UNITED STATES PATENT AND TRADEMARK OFFICE

APPLICATION NO.	FILING DATE	FIRST NAMED INVENTOR	ATTORNEY DOCKET NO.	CONFIRMATION NO.
10/516,659	12/01/2004	Hermann Baumann	P/4674-2	8761
7590 Klaus P. Stoffel, Esq. Wolff & Samson PC One Boland Drive West Orange, NJ 07052			EXAMINER TRIEU, THAI BA	
			ART UNIT 3748	PAPER NUMBER

Office Action Summary

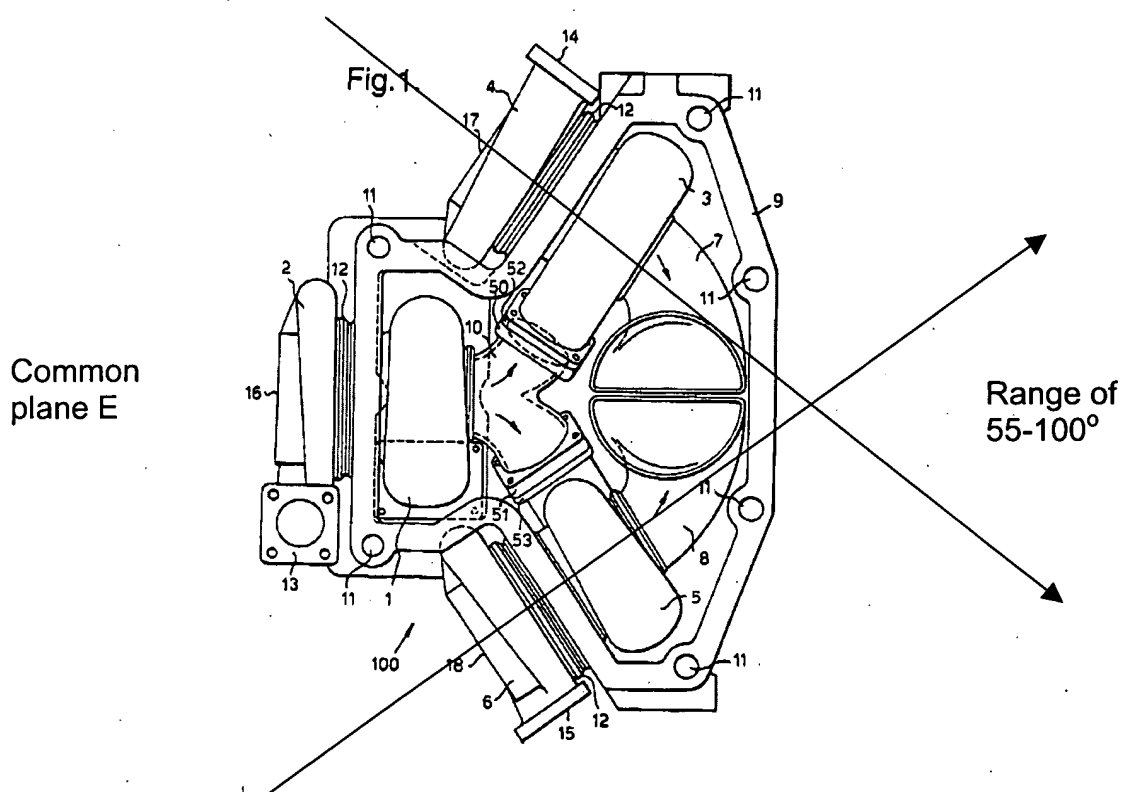
Ramsden discloses an internal combustion engine with a first and a second exhaust gas turbocharger (3, 4; 5, 6) for charging the internal combustion engine, each of the exhaust gas turbochargers comprises a compressor wheel and a turbine wheel, which rotate around a common charger axis (Not Numbered), a first exhaust gas feed line arranged to lead to the first exhaust gas turbocharger, a second exhaust gas feed line arranged to lead to the second exhaust gas turbocharger, the two exhaust gas turbochargers (3, 4; 5, 6) having parallel air flows, a carrier housing (9) arranged to hold the two exhaust gas turbochargers, a manifold arranged to collect exhaust gas streams downstream of the two exhaust gas turbochargers (3, 4; 5, 6), and a common exhaust gas discharge line (10) connected to the turbochargers (3, 4; 5, 6), the two exhaust gas turbochargers (3, 4; 5, 6) being arranged so that the two charger axes are at an angle to each other in a range of 55-100° and lie in a common plane (E) (See Figures 1, 3, and 4);

wherein the plane is parallel to a top of the internal combustion engine
(See Figure 4);

wherein the exhaust gas discharge line is arranged to lie in the plane
(See Figure 4);

wherein the engine includes a cylinder heads and further comprises air
feed lines (24a, 24b) located above the cylinder heads for supplying
uncompressed air to the two exhaust gas turbochargers (3, 4; 5, 6);

filters (not shown) installed in an upstream direction of the air feed lines (24a,
24b) on an unpressurized side of the turbine wheel; and
a third exhaust gas turbocharger (1, 2) installed in the carrier housing (9) ;

wherein the third charger (1, 2) is arranged so as to have a charger axis
that lies in the plane (E) and within the angular range.
